February 1, 1993

Subject: Response to Comments Regarding a Proposed Soil Placement Plan at the General Electric Company Vallecitos Nuclear Center (GE-Vallecitos), Pleasanton, California.

FIGURE 2
WATER ELEVATIONS
JULY 26, 1991

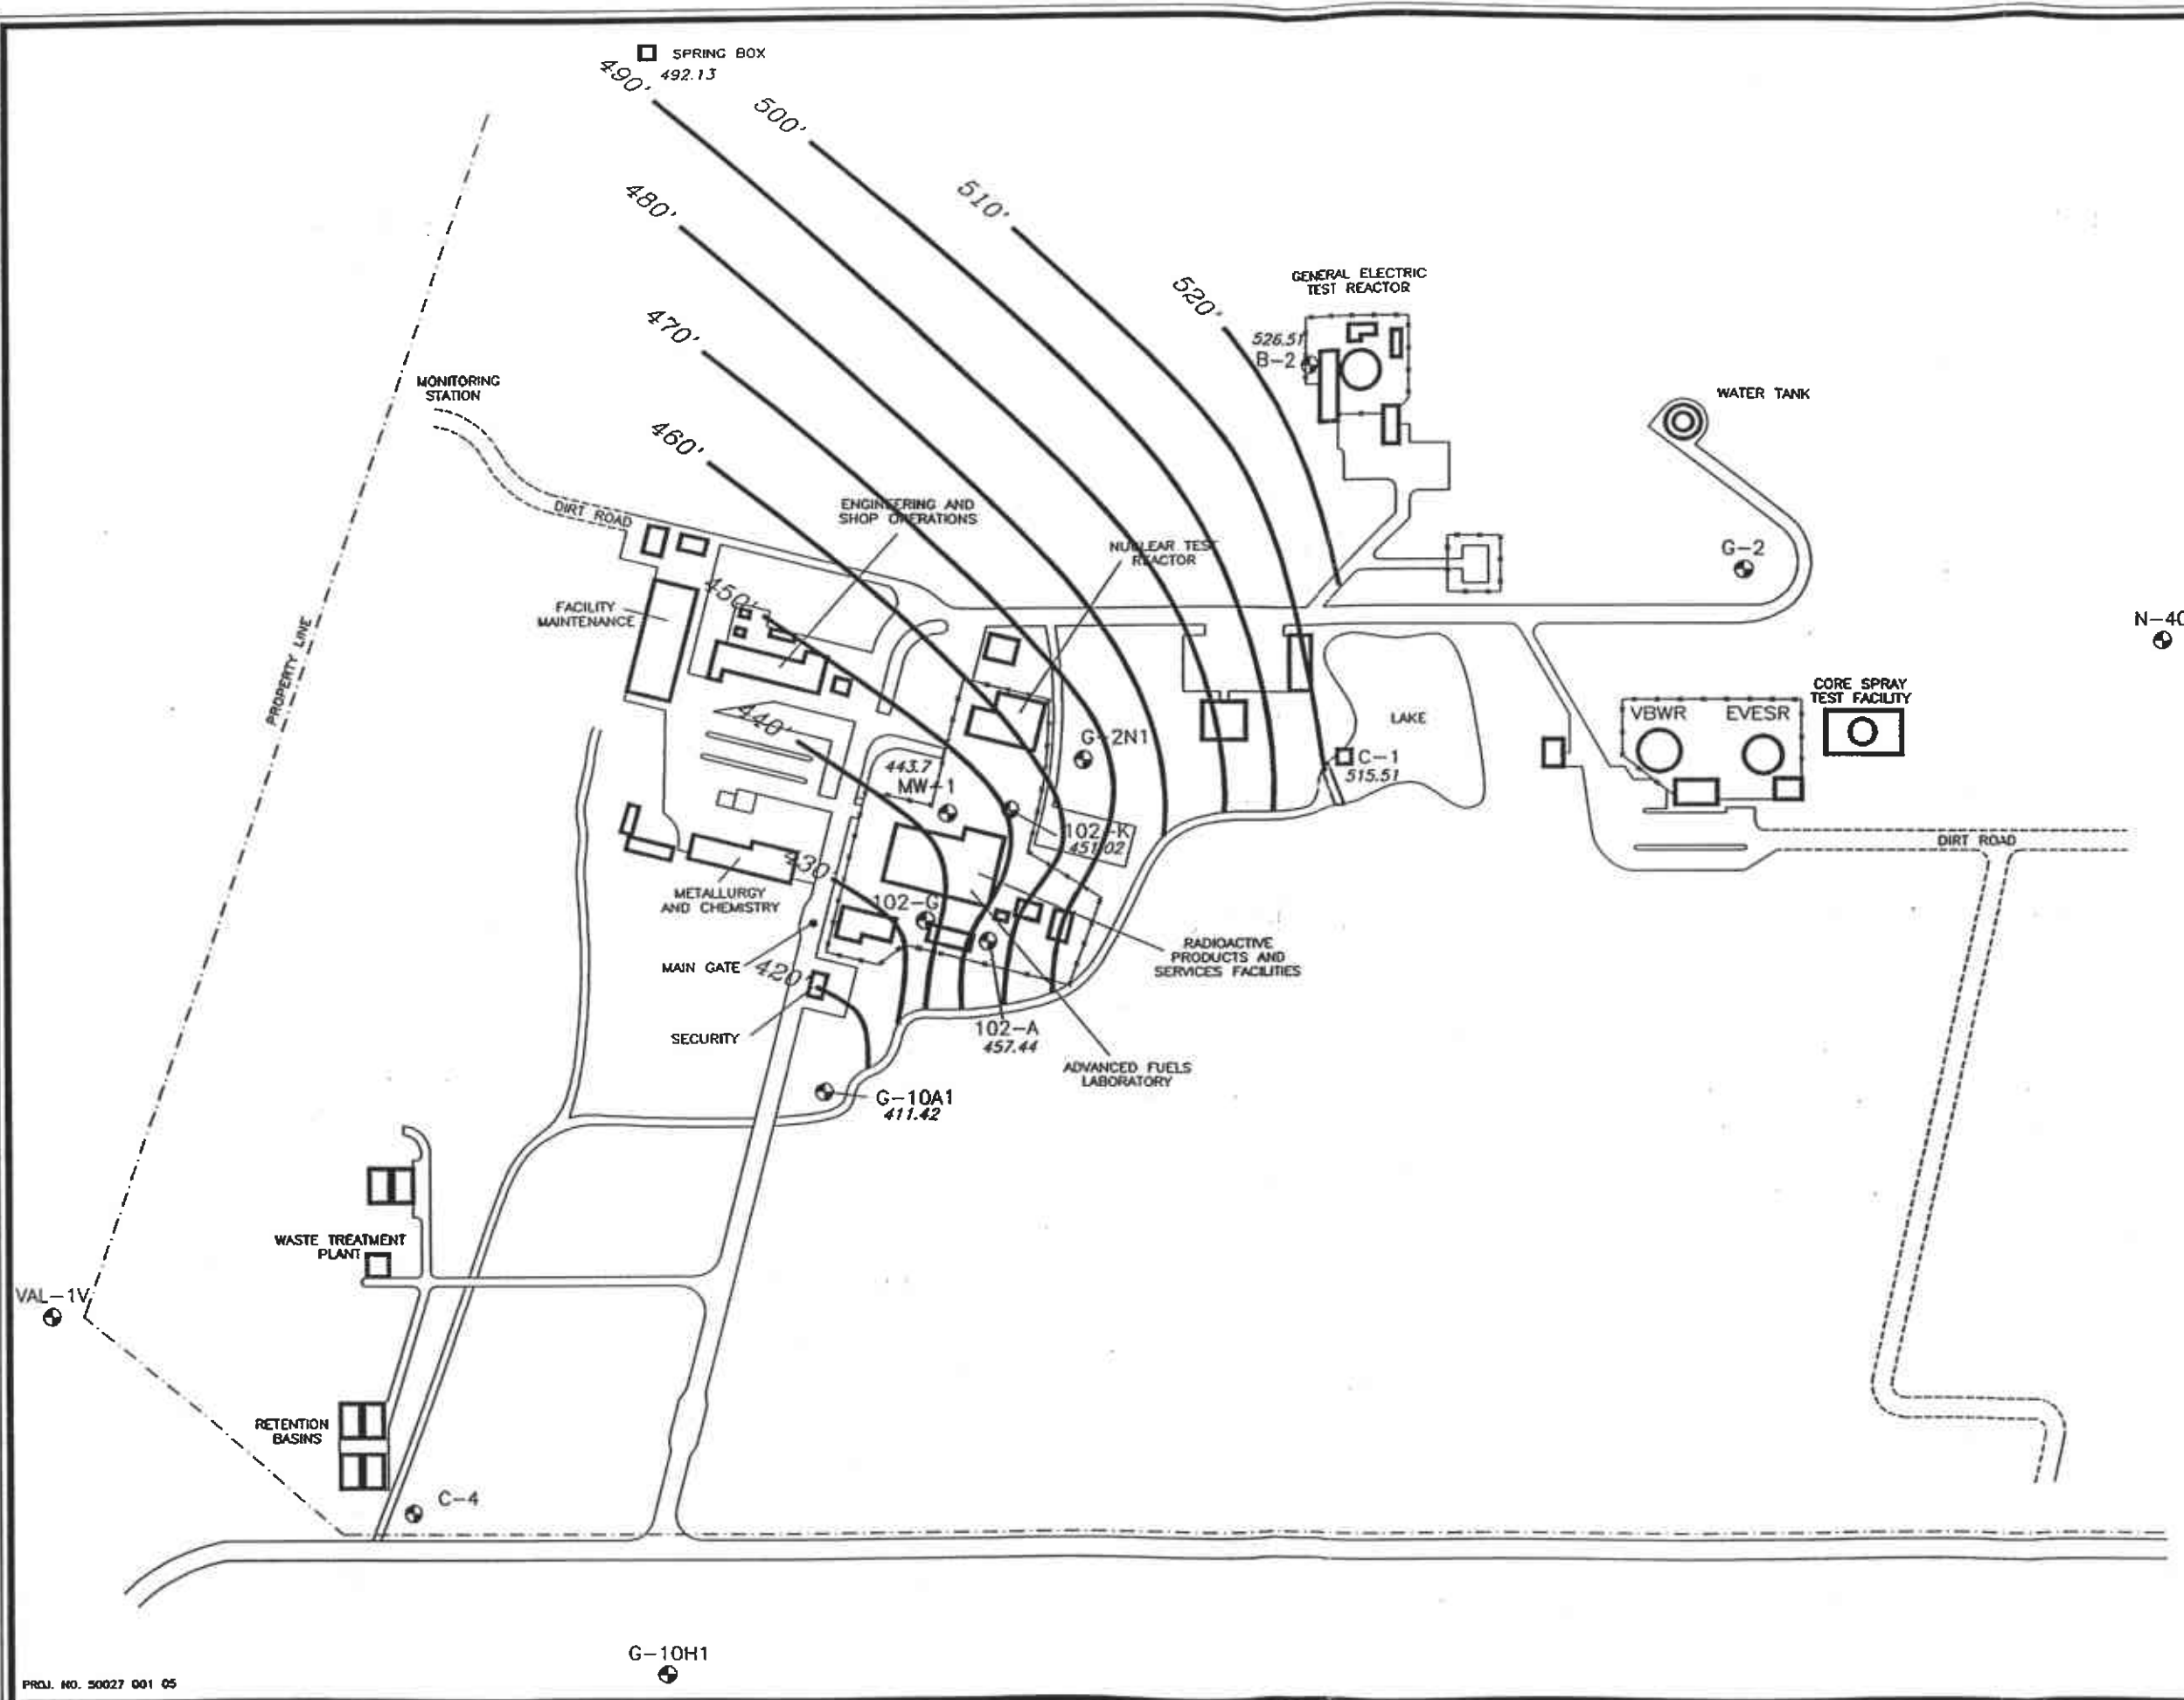
A groundwater monitoring network consisting of 9 monitoring wells exists at the GE-Vallecitos site. These monitoring wells are currently on an annual monitoring program which includes analysis for volatile organic compounds by EPA method 8240 (includes benzene, toluene, ethylbenzene, and xylenes). Five of these eight groundwater monitoring wells are located down-gradient of the proposed placement area. The location of these wells allows early detection of any potential groundwater impact. The results of the latest groundwater monitoring and sampling were documented in SEACOR's "REPORT ON ENVIRONMENTAL CONSULTING AND FIELD SERVICES, VALLECITOS NUCLEAR CENTER FACILITY, VALLECITOS ROAD, PLEASANTON, CALIFORNIA, JUNE 11, 1992", a copy of the groundwater gradient map from this latest report is attached.
